EAST 38TH AVENUE  
INFRASTRUCTURE SITE PLAN

38TH AVENUE WIDENING

INFRASTRUCTURE SITE PLAN

TITLE: COVER SHEET

RETAINING WALL TYPICAL SECTION

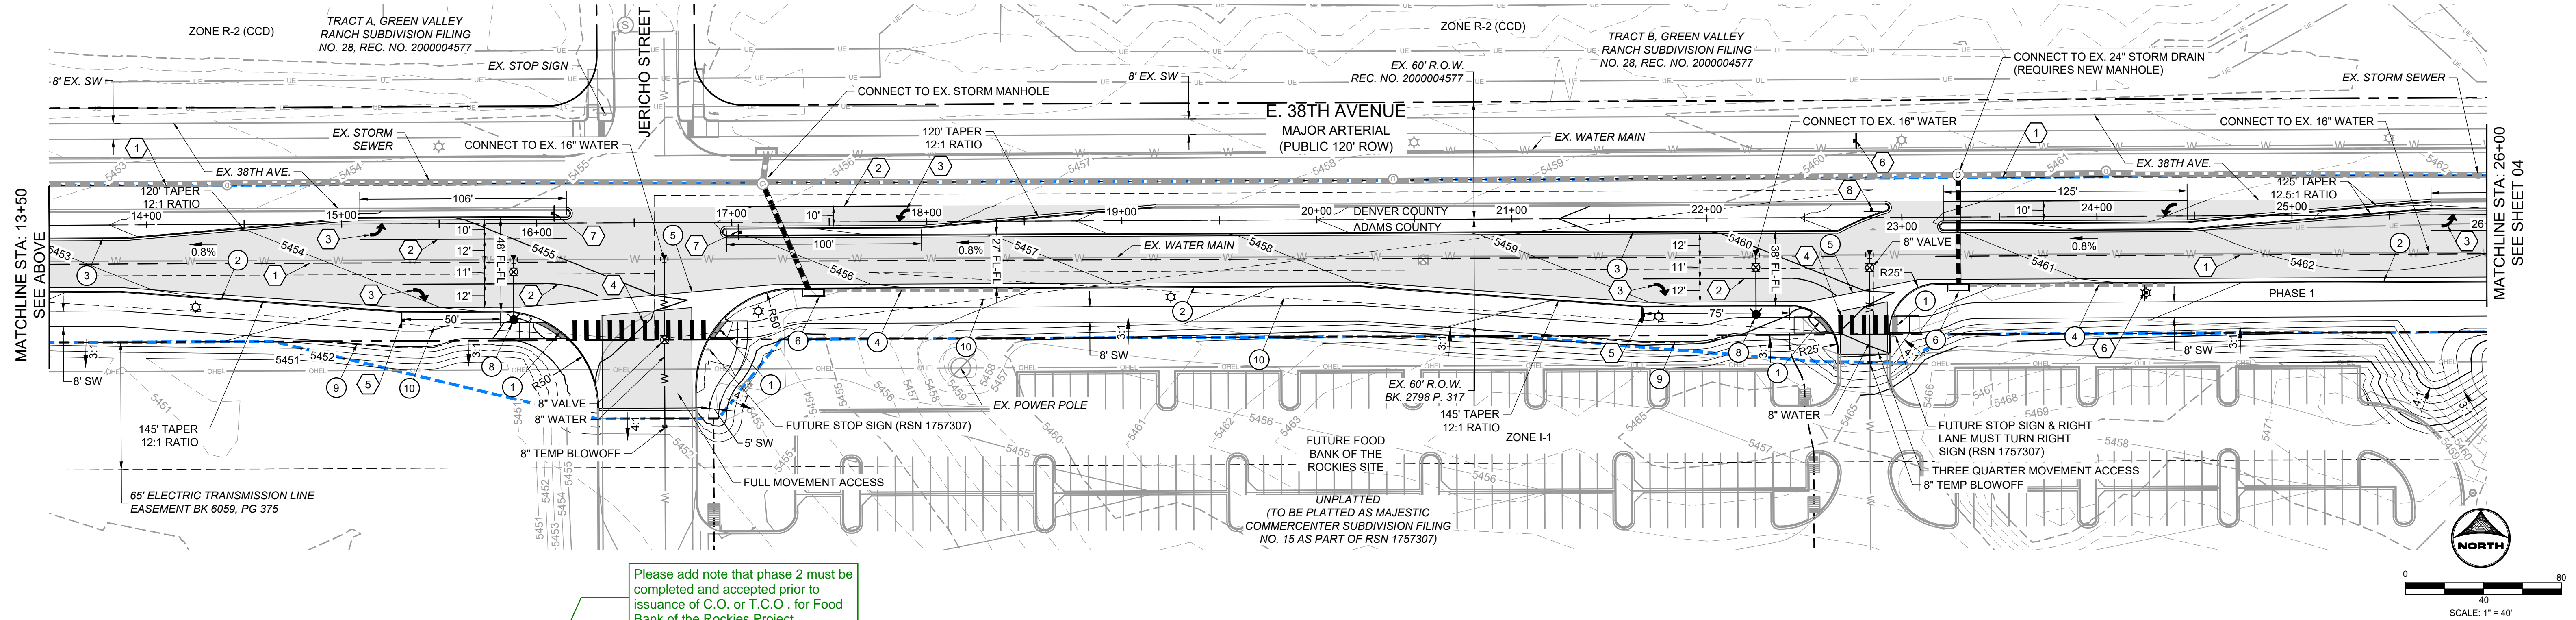
Advisory Note:  
Structural calculations for this proposed retaining wall, per section 4.02.7 of the COA Roadway Design & Construction Specifications, will be required with the 1st review submittal of the Civil Plans.

Please remove this verbiage.  
Structural calculations must be submitted with 1st review of Civil Plans.

Please label as 'PRIVATE'  
Labeled as private.

Advisory Note:  
License Agreement will be required for private retaining wall within public ROW.

Please label as 'PRIVATE'  
Labeled as private

Acknowledged.  
Structural calculations were submitted with the Civil Plans.

Verbiage of notes have been modified.  
Structural calculations were submitted with the Civil Plans but contractor will still be responsible for shop drawings and structural permits.

Acknowledged.  
A license agreement is in progress and is submitted to licenseagreement@auroragov.org.
